#### ADDENDUM NO. 1

### O'SHERIDAN STREET, LAWRENCE STREET AND BRESLAND COURT ASSESSMENT DISTRICT - 2012

#### CONTRACT NO. 6788

### CONTRACT NO. 6788

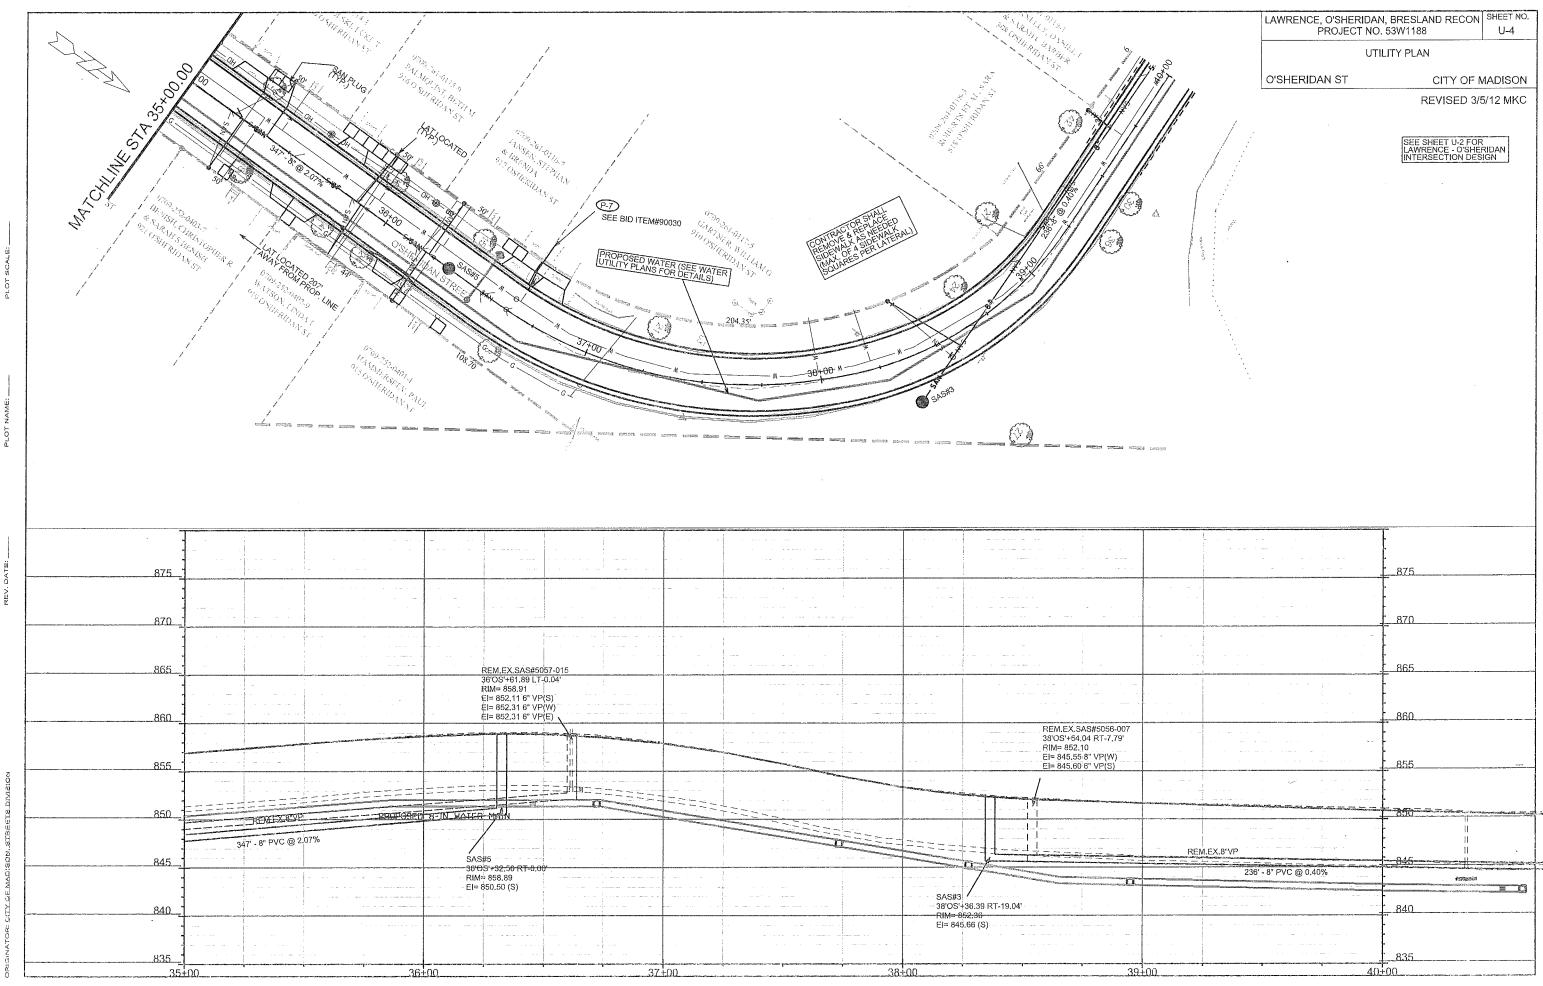
INSERT PAGES E-5 TO E-9 (Revised 3/5/12): Quantity decreased for Bid Item 50771 Internal Chimney Seal

UNIT PRICE	
ITEM	TYPE OF WORK	ESTIMATE	QUANTITES	BID	TOTAL BID
50361	WASTEWATER CONTROL	1.00	LUMP SUM		
50390	SEWER ELECTRONIC MARKERS	104.00	EACH		
50701	4' DIA SANITARY SAS	6.00	EACH		
50771	INTERNAL CHIMNEY SEAL	2.00	EACH		and the same of th
50780	CLEANOUT (UNDISTRIBUTED)	2.00	EACH		
50791	SANITARY SEWER TAP	2.00	EACH		
ł	TARY SEWER ACCOUNT NO. ES ATER ACCOUNT NO. EW01-5827			•	)
50202	DEWATERING TYPE II	1.00	LUMP SUM		
WATE	R ACCOUNT NO. EW01-58273-8	10455-00-	53W1188		
10703	TRAFFIC CONTROL FOR WATER MAIN INSTALLATION	1.00	LUMP SUM		
10913	MOBILIZATION FOR WATER MAIN INSTALLATION	1.00	LUMP SUM		
70002	FURNISH AND INSTALL 6 INCH PIPE & FITTINGS	108.00	L.F.		
70003	FURNISH AND INSTALL 8 INCH PIPE & FITTINGS	2,106.00	L.F.		
70407	FURNISH AND INSTALL HYDRANT	5.00	EACH		
70408	SELECT FILL - SAND FOR WATER	2,214.00	L.F.		
70413	FURNISH AND INSTALL STYROFOAM	32.00	L.F.		
70414	CUT OFF EXISTING WATER MAIN	3.00	EACH
